Plumbing for new style drive motor P/N 140849

If replacing both drive motors refer to this diagram.

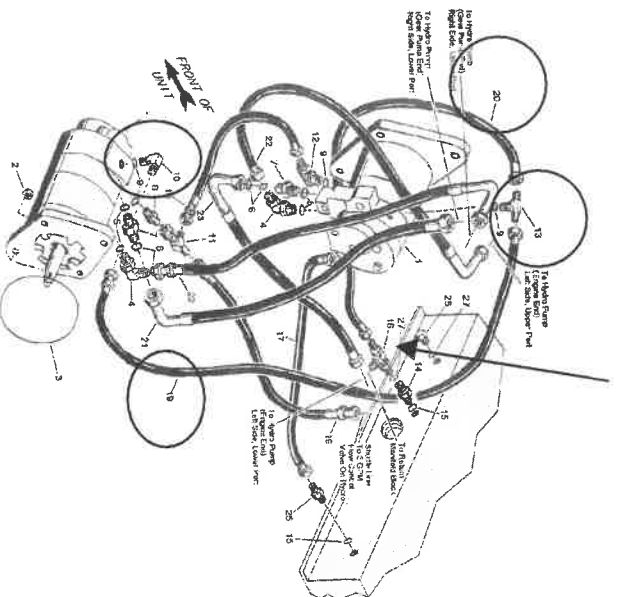
Old style drive motors have a secondary drain system. This is not used on new style motors. If replacing both drive motors, remove and discard items 10, 19, 13 and 20. Cap the T item 16 where hose item 20 was removed.

If replacing just one drive motor refer to these diagrams.

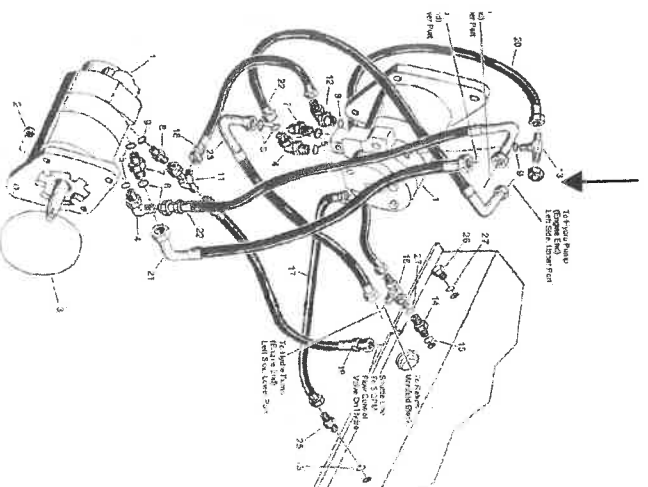
Left side motor replacement only – discard elbow # 10 and hose # 19 from left drive motor. Cap T on top of right drive motor.

Right side motor replacement only – discard T # 13 from top of right drive motor and connect hose # 19 and hose # 20 together.
